DEVELOPMENT CONTROL COMMITTEE

ADDENDUM SHEET

4/02300/13/FUL - DEMOLITION OF HOUSE AND CONSTRUCTION OF FIVE HOUSES (FOUR SEMI-DETACHED AND ONE DETACHED)

4/01941/15/FHA - CONSTRUCTION OF DRIVEWAY AND HARDSTANDING TO THE FRONT AND SIDE OF EXISTING HOUSE

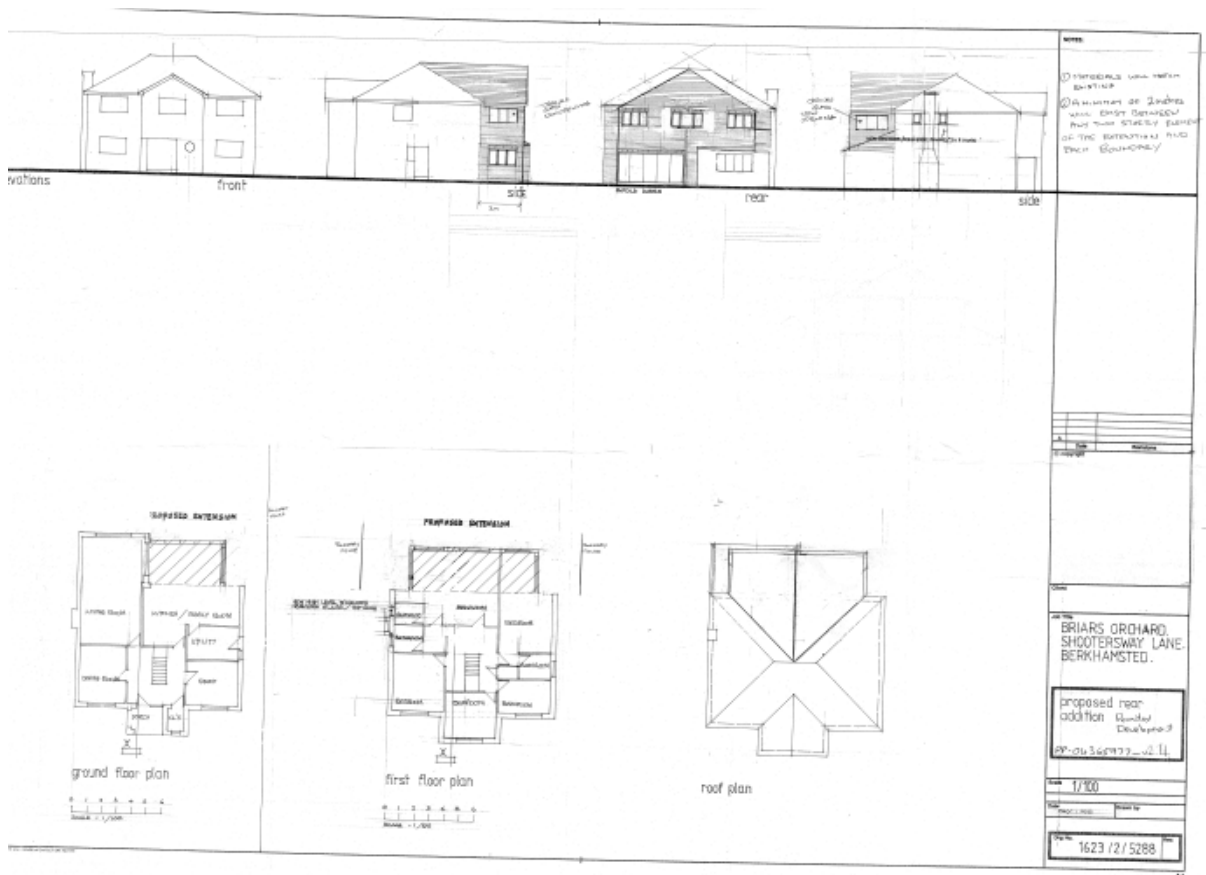
Plans were amended during the assessment of the proposal but the final plans being considered are below.

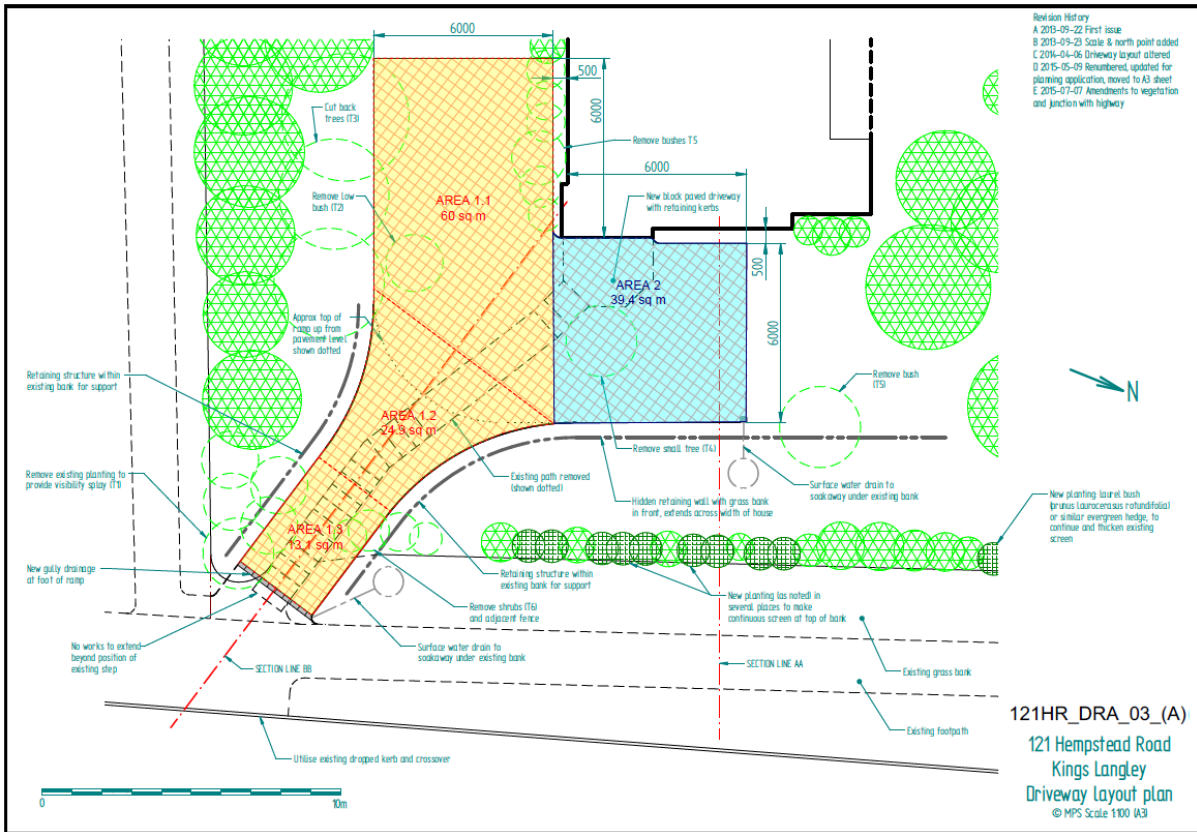
Final comments from Nick Gough (Highways Officer): “I am satisfied that it shows an arrangement that could provide access that would make a reasonably safe connection to the public highway. However it is an offence to discharge surface water on to the public highway and in order to prevent this, details will be required prior to construction of the drainage system that will need to be robust enough to operate without frequent clearing”. “The ‘approved plans’ condition sounds fine”.

To satisfy Hertfordshire Highways, two additional documents were submitted regarding drainage (see below). If approved, the drainage plan would be conditioned (see Condition 3 - approved plans).

1. Refer to the attached marked-up drawing 121_HR_LAY_02_(E) Drainage Mark-up.
2. The drainage scheme and calculations have been designed in accordance with the Buildings Regulations 2010, Approved Document H Drainage and waste disposal, 2015 edition (taken from http://www.planningportal.gov.uk/uploads/br/BR_PDF_AD_H_2015.pdf).

3. Drainage requirements are calculated as follows:
 - a. Natural falls divide the driveway into two areas, shown as Area 1 and Area 2 on the attached.
 - b. Area 1 (divided into 3 parts for ease of mark-up and calculation) totals:
 $60 + 24.9 + 13.1 = 98\text{m}^2$

- c. The rainfall intensity for the above location, taken from diagram 2 of the Approved Document H3 section 2, is 0.016 l/s/m^2
 - d. This gives a maximum design run-off from Area 1:
 $98 \times 0.016 = 1.57 \text{ l/s}$

- e. Run-off from Area 2:
 $39.4 \times 0.016 = 0.63 \text{ l/s}$
4. For drainage products reference has been made to the *Linear Drainage Design Guide* published by Marshalls Paving (<http://www.marshalls.co.uk>). A class B125 drainage channel is required across the bottom of the driveway, to take the vehicular loads.

A suitable product would for example be the Birco Lite with 0/0 channel unit. This has an internal channel width of 100mm and depth of 120mm. This channel has a hydraulic capacity of 2 l/s when laid nominally flat.

5. The channel grating needs to have a relatively high open area, due to the location at the foot of the ramped section of the driveway. The dynamic loading will be relatively high in this position, so for example an aluminium or galvanised cast iron grating with 100 x 12mm slot pattern with 46,900 mm^2/m open area should be chosen.

6. The drainage channel will be terminated with a gully and silt trap, which drains to a soakaway using nominal 110mm diameter underground pipework.
7. Area 2 will be drained from a similar gully, silt trap and pipe to a soakaway.

8. The soakaways will be constructed in accordance with the Approved Document H3 section 2 paragraph 3.26 (for areas less than 100 m^2) i.e. a circular pit filled with rubble or formed from perforated ring units. Dimensioning of the soakaway is to be suit the on-site characteristics of the local soil (refer to Approved Document H2 section 2 paragraphs 1.34-1.37).
